Notice of Allowability

10/751,182

EXAMINER'S AMENDMENT

Fig. 2

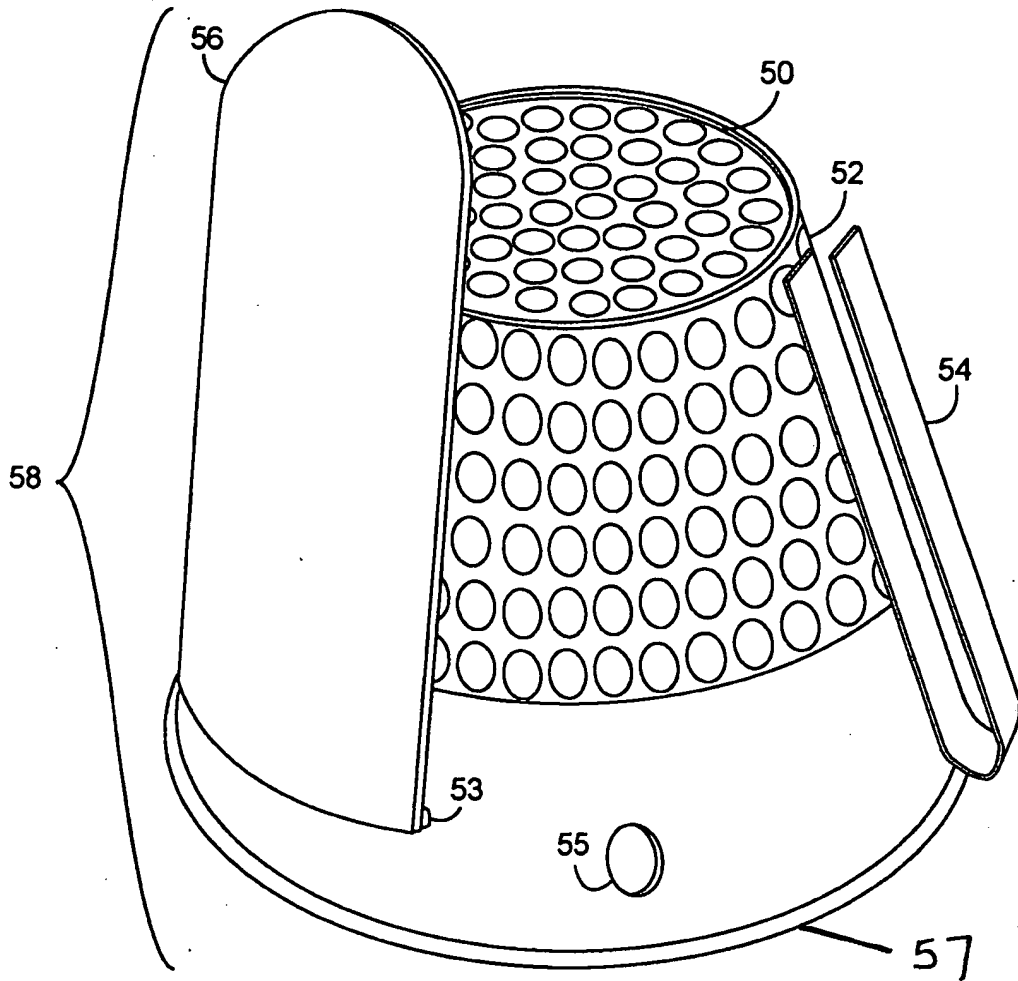
2. The following changes to the drawings have been approved by the examiner and agreed upon by applicant: inserted no. 57 into Fig. 2 to denote the large end and inserted nos. 67 and 69 to denote the one end of the attachment strip and the another opposite end of the attachment strip in Fig. 3. In order to avoid abandonment of the application, applicant must make these above agreed upon drawing changes.
